## RESIDENTIAL BUILDING PERMIT APPLICATION

Street Address: 14041 Tridelphia Road		Unit:
City: Glenelg	State: MD	Zip Code: 21737
Subdivision/Village/Complex Name:		SDP/WP/BA #:
Lot:	Tax Map:	Parcel:
Grading Permit #:

**RE: Waiver Approval**  
14041 Triadelphia Road  
Glenelg, MD 21737

SITE INSPECTION SHEET

PROPOSED  
ADDITION  
9'x12'  
OVER  
EXISTING  
DECK

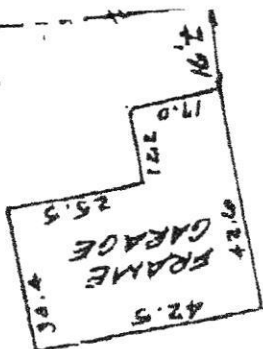
This letter is being issued as a follow-up to the approval of your waiver request dated June 22, 2022 and the site visit conducted on June 28, 2022. Please be advised that the site visit revealed that the existing well with tag number HO-73-4113 is in unsatisfactory condition. The well cap and electrical conduit need to be repaired ***prior to Health Department approval of building permit B22002265.***

Your request to waive the requirement of the Howard County Code for a percolation certification plan has been **approved**. The proposed living space addition is less than one hundred (100) square feet, does not increase the number of bedrooms, and has little to no impact on the area available for future on-site sewage disposal system repairs.

Any deviations from the proposed work illustrated on the site plan submitted with the waiver request will be subject to further review by this department. Future property improvements that require a building permit will require percolation testing and a percolation certification plan.

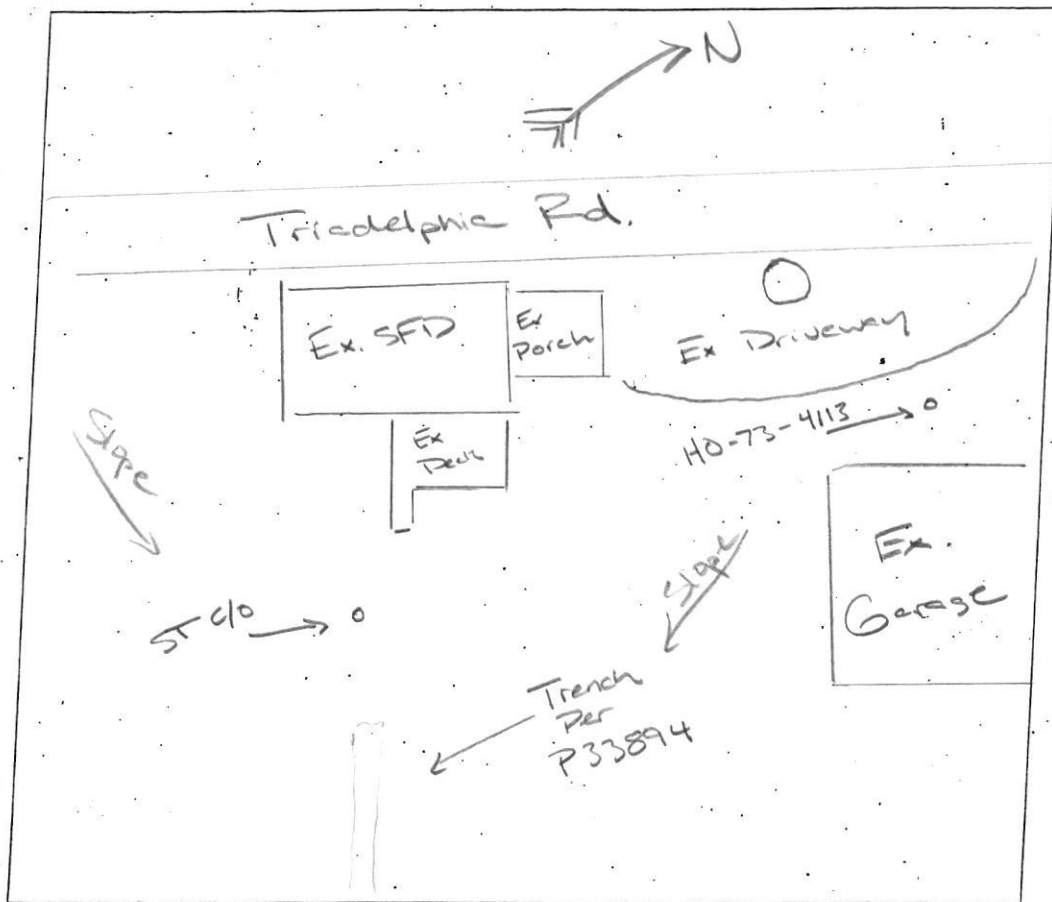
COMMENTS: Well condition unsatisfactory needs cap and  
conduit fixed. Well casing is above grade and was  
GPS located. Septic system appears to be in functioning  
condition, no signs of failure. Cleanout could use  
a new cap. No cap was observed but was covered with cinder block  
pieces.

Well HO-73-4113  
(Cap Broken, No Conduit)  
6/28/2022

ST C/O  
(No cap)
